AMENDMENTS TO THE DRAWINGS

REMARKS

Fig. 2
Conventional Art

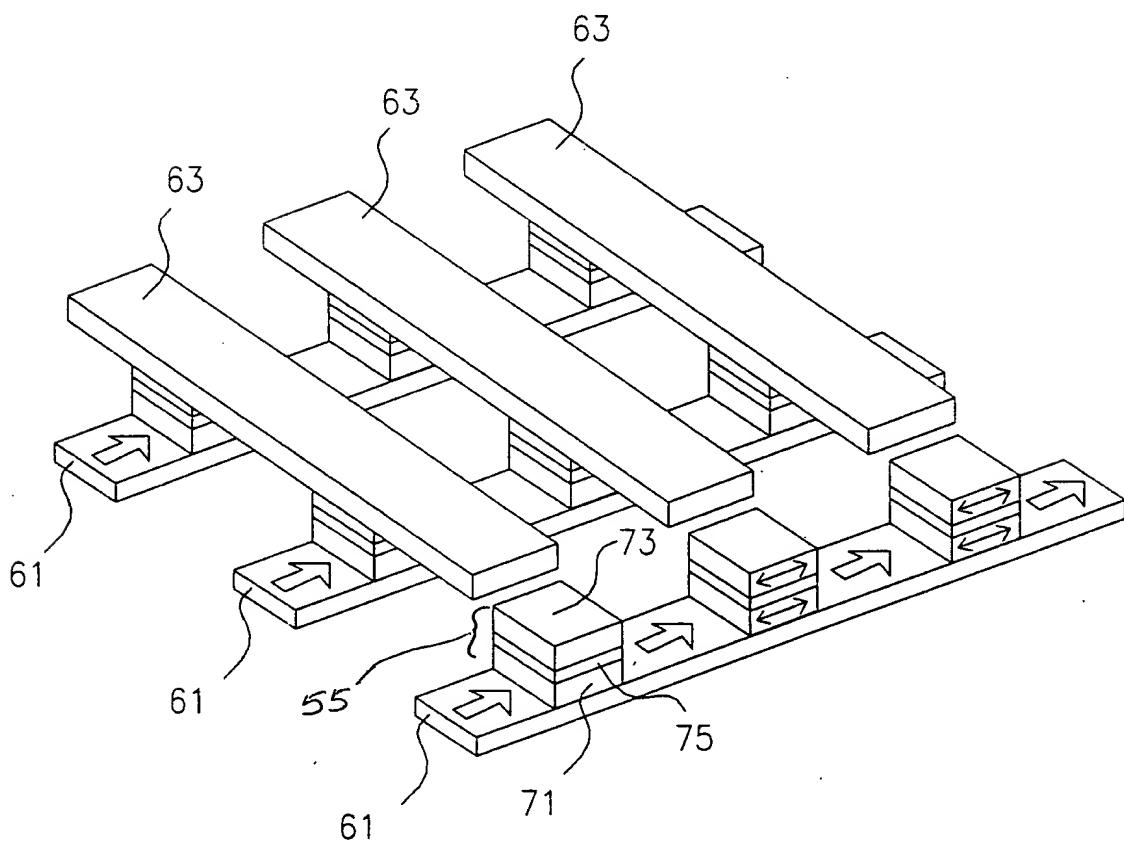
In Figure 2, add reference numeral 55 and its lead line; and

The Examiner objected to the drawings as failing to show reference numeral 55. Applicants have now amended Figure 2 to add this reference numeral and the appropriate lead line.
